A d d e n d u m

Iowa Department of Transportation
Office of Contracts

B.O.	Proposal ID	Proposal Work Type	County	Project Number	Addendum
103	07-0636-078	PCC PAVEMENT- GRADE & REPLACE	BLACK HAWK	NHSX-063-6(78)--3H-07 NHSX-063-6(91)--3H-07 NHSN-063-6(95)--2R-07	20DEC103A08

Summary of change the plans to the follow following plan sheets: NHSX-063-6(78)--3H-07

SOUTH PUMP STATION - TOP PLAN

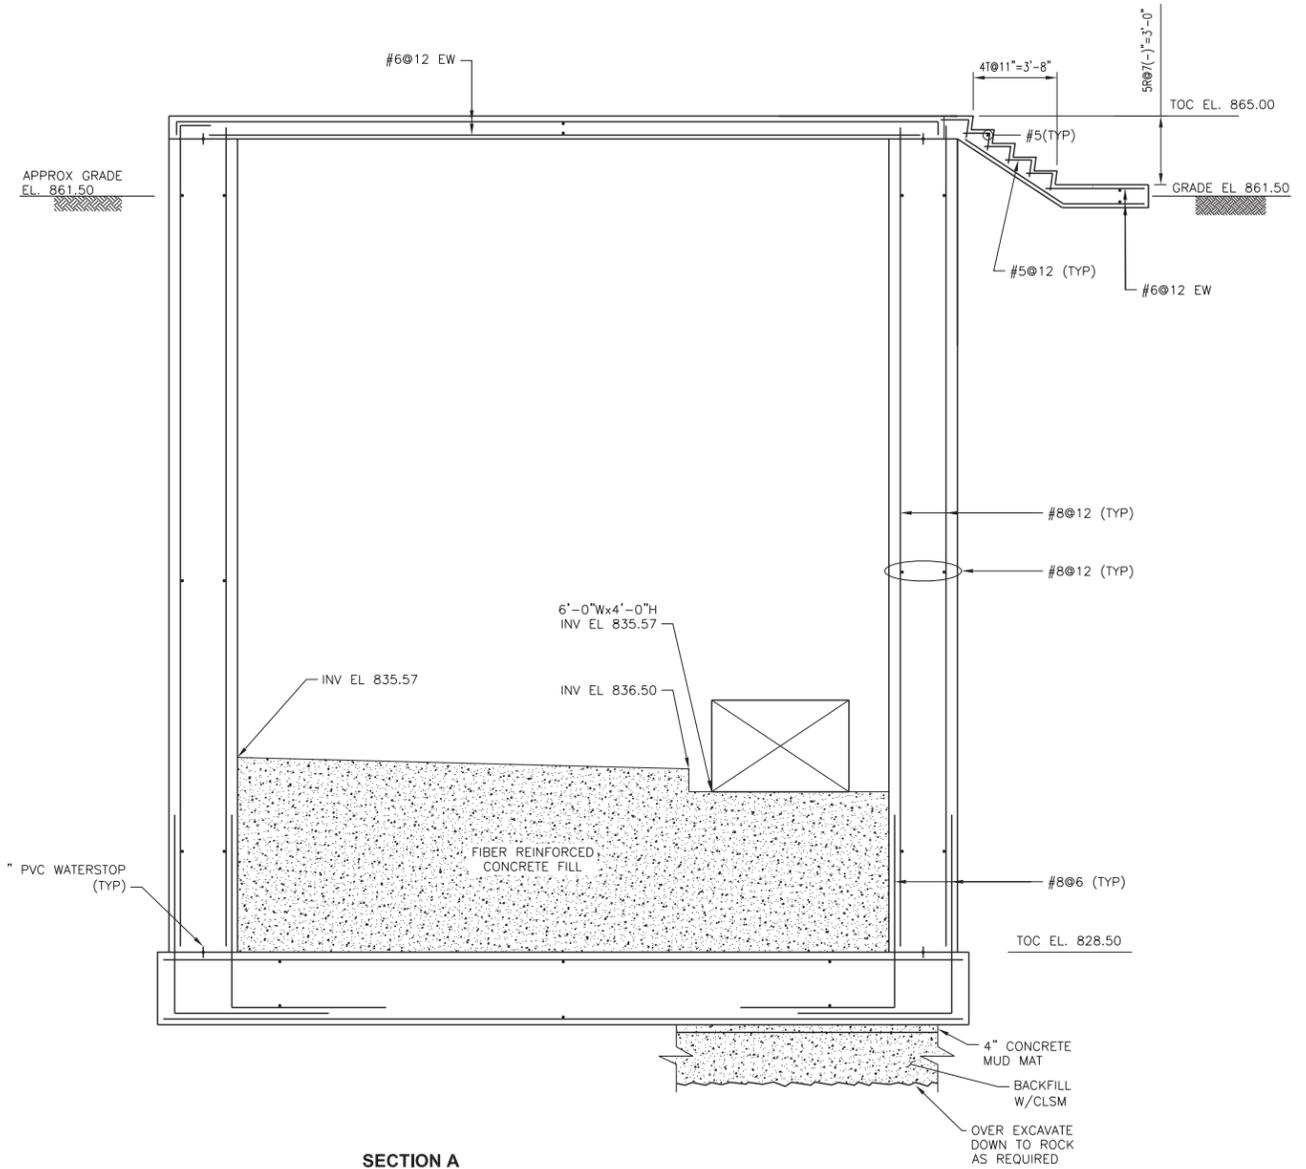
Sheet M.317	Plan Sheet Change	Added dimension for foundation overhang on “Foundation Plan”.
Sheet M.318	Plan Sheet Change	Showed Aluminum Grating in “Foundation Plan”.

SOUTH PUMP STATION - SECTIONS

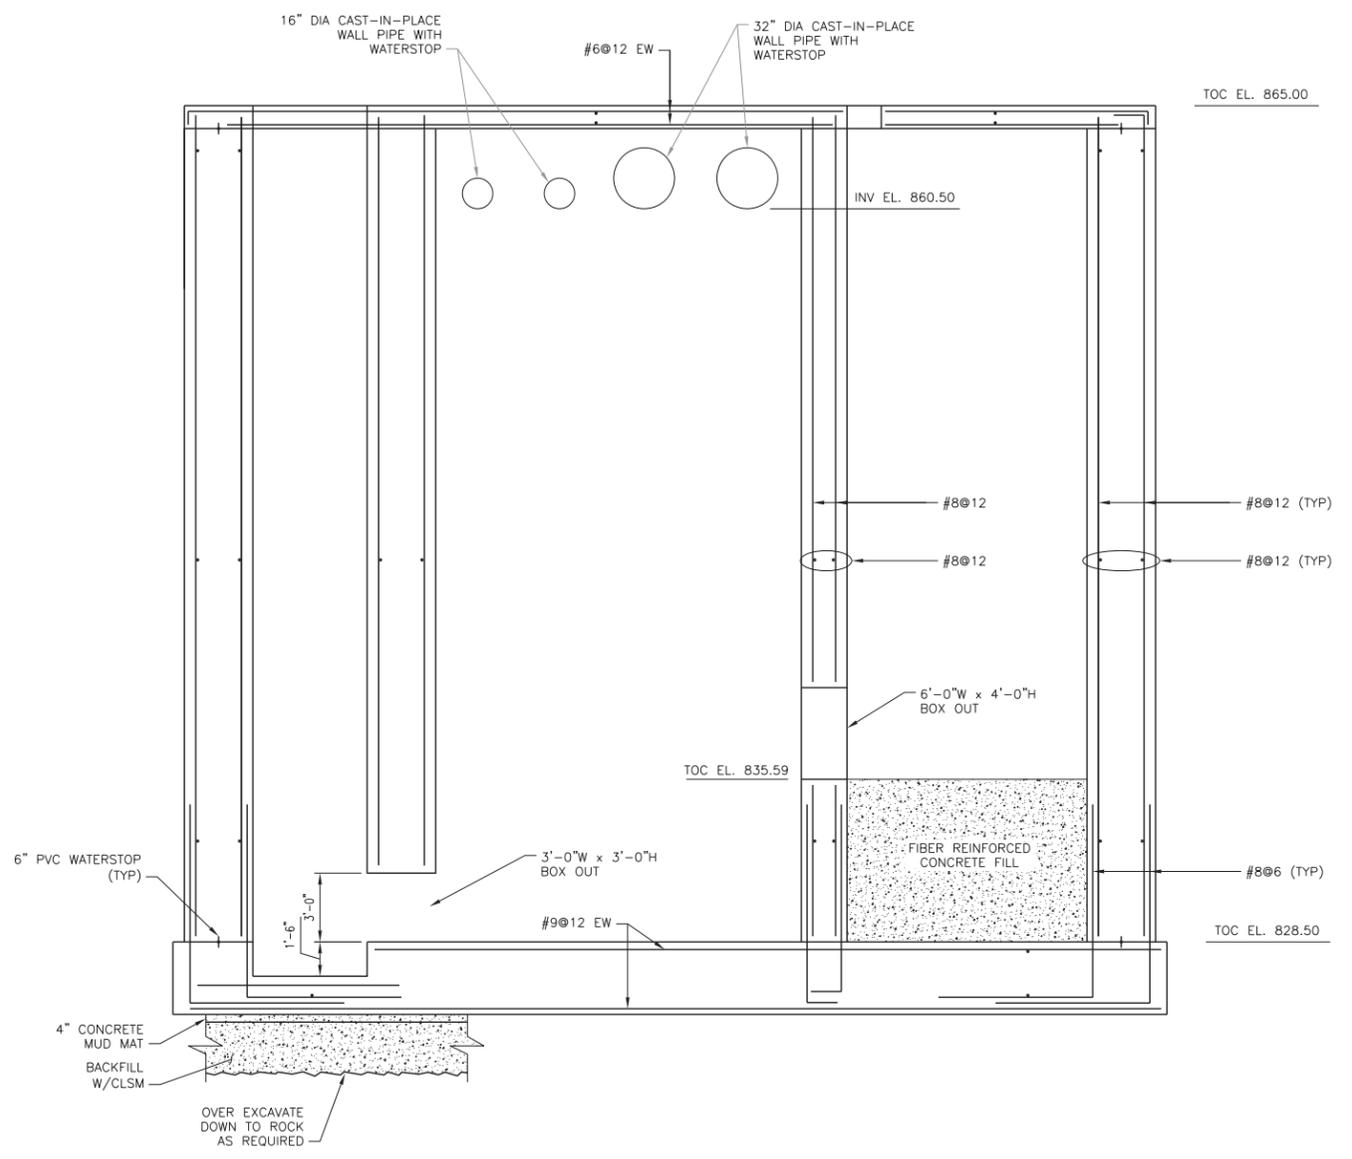
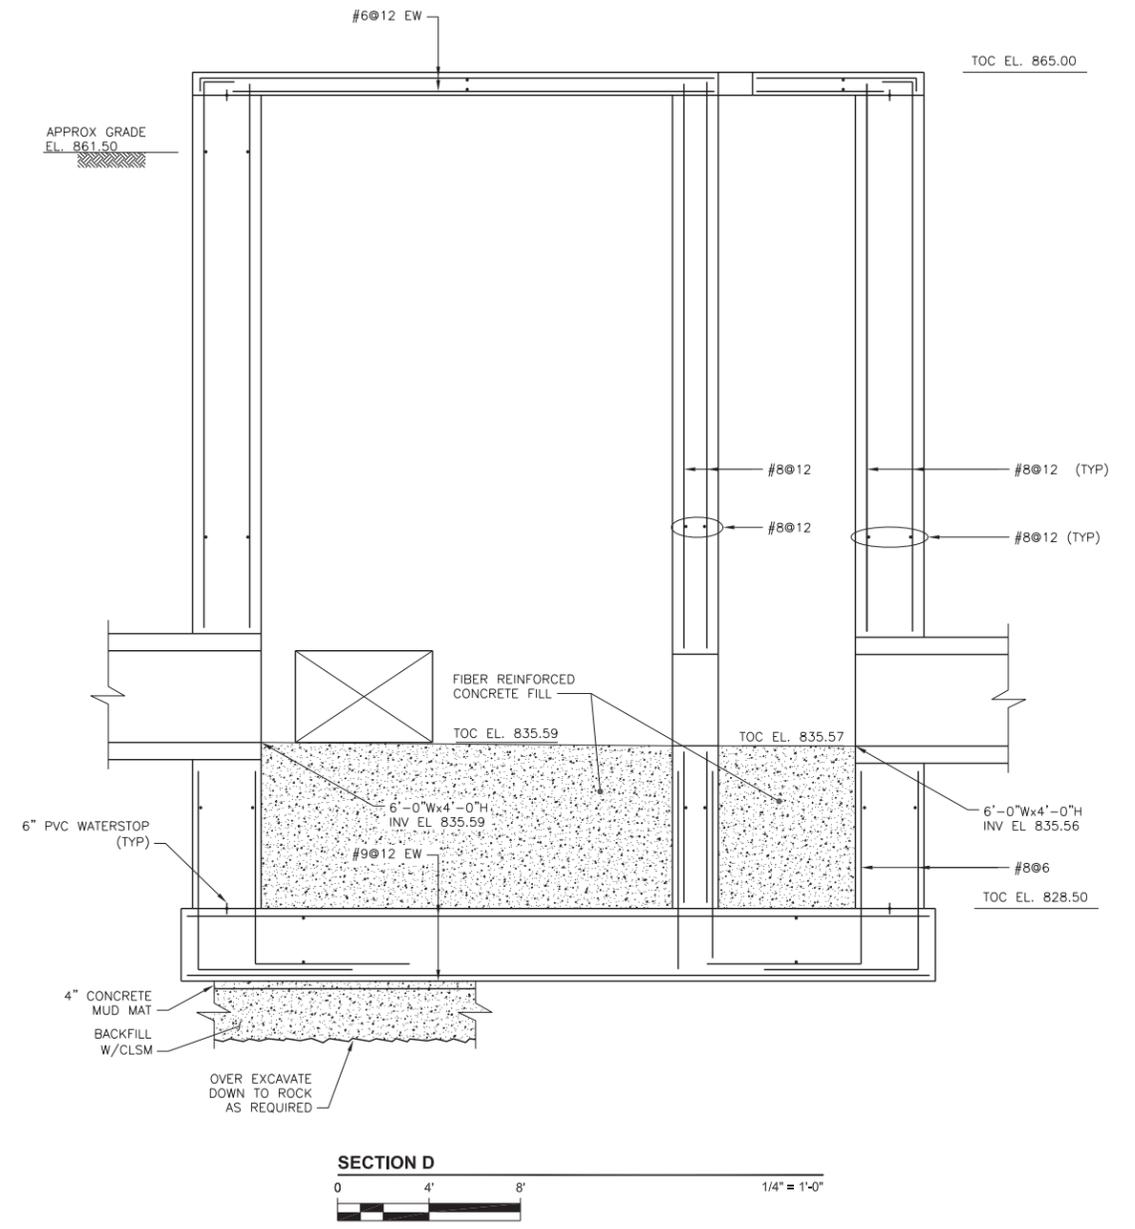
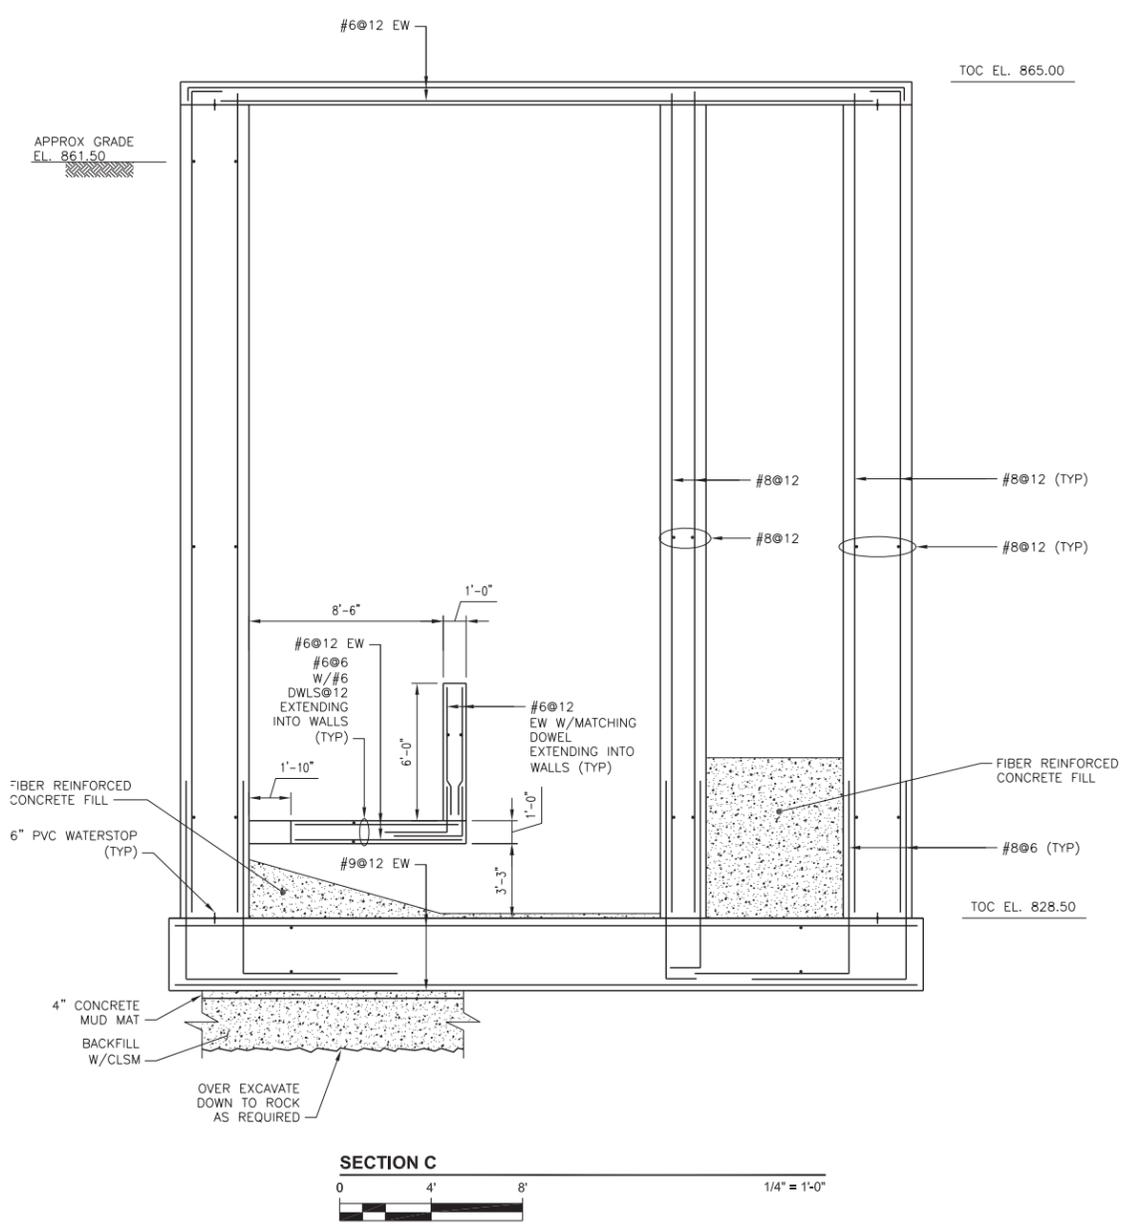
Sheet M.319	Plan Sheet Change	Added “Fiber Reinforced Concrete Fill” callout on “Section A” and “Section B” and callouts for box out sizes on “Section B”.

SOUTH PUMP STATION - SECTIONS

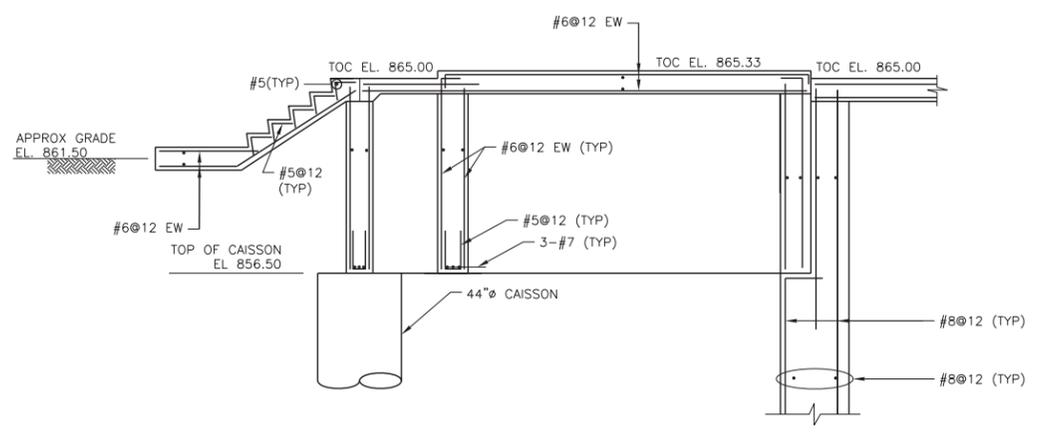
Sheet M.320	Plan Sheet Change	Added “Fiber Reinforced Concrete Fill” callout on “Section C” and “Section D” and revised internal vertical wall height and added internal vertical wall dimension on “Section C”.

SOUTH PUMP STATION - SECTIONS

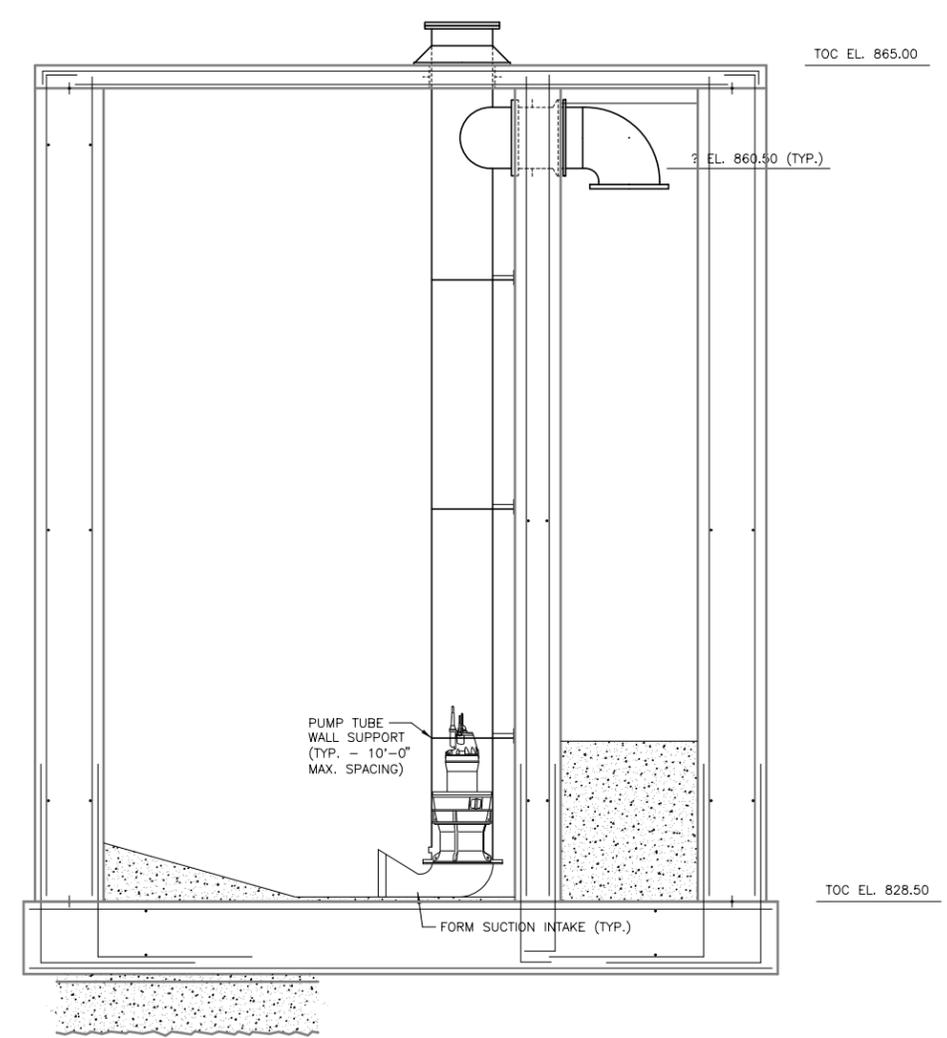
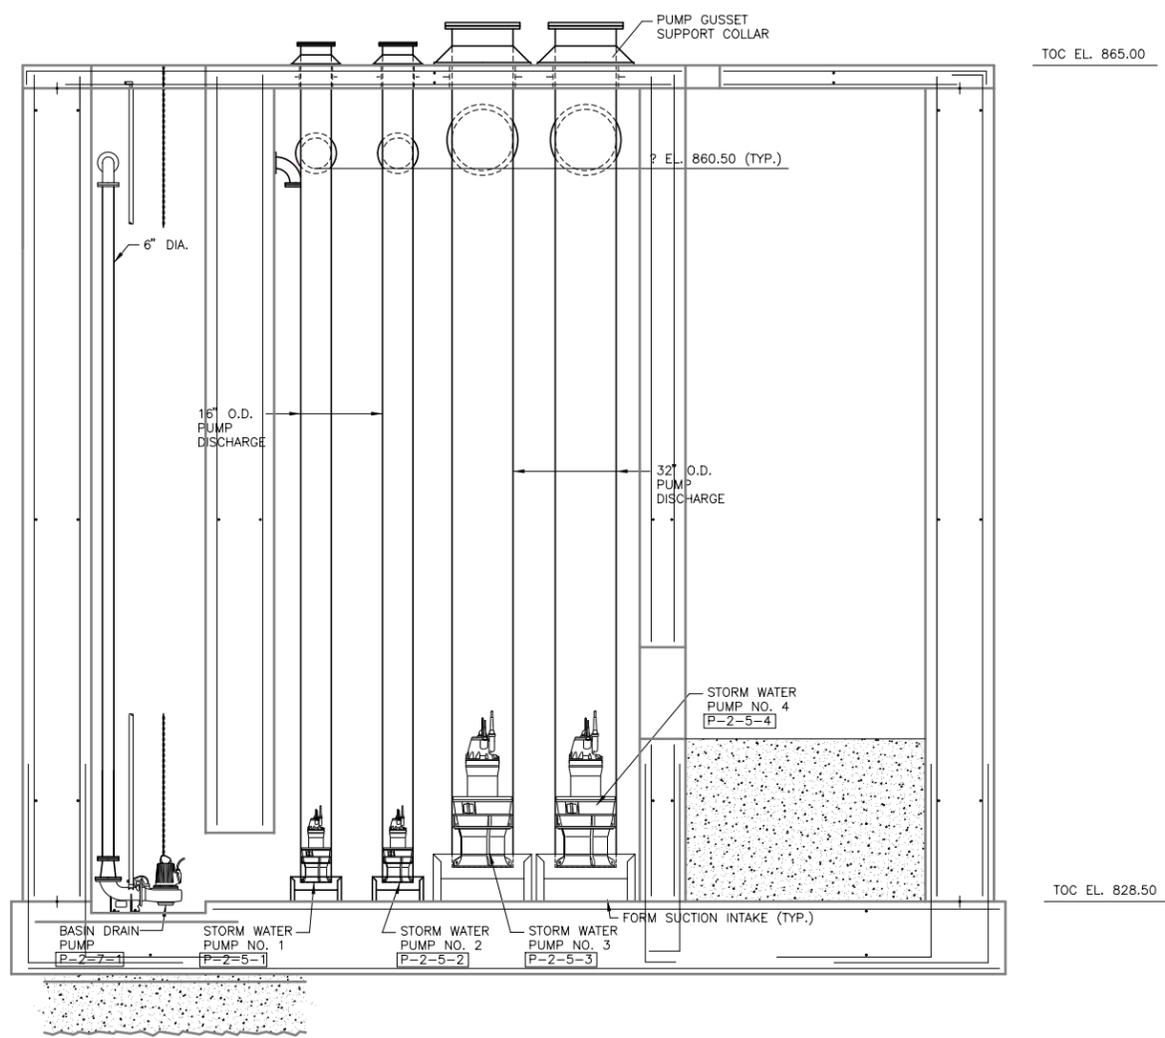
Sheet M.321	Plan Sheet Change	Added note concerning caisson installation and testing under “Section E”.
Sheet M.325	Plan Sheet Change	Added pump tube wall supports and revised pump tube wall support note on “Section C”.

NOTE: CAISSON INSTALLATION AND TESTING SHALL MEET THE REQUIREMENTS OF SECTION 2433, CONCRETE DRILLED SHAFTS, OF THE IDOT STANDARD, SPECIFICATIONS FOR HIGHWAY AND BRIDGE CONSTRUCTION, AS WELL AS ALL APPLICABLE IDOT DEVELOPMENTAL AND SUPPLEMENTAL SPECIFICATIONS.

SOUTH PUMP STATION - ELECTRICAL SERVICE PLANS

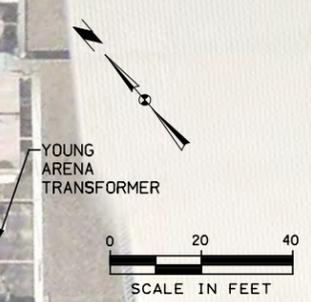
Sheet M.328A	Plan Sheet Addition	Added a new plan sheet showing the electrical service for the South Pump Station.

DIRECTIONAL BORE CONDUIT FROM EDGE OF PARKING LOT TO TRANSFORMER AT MANATT'S
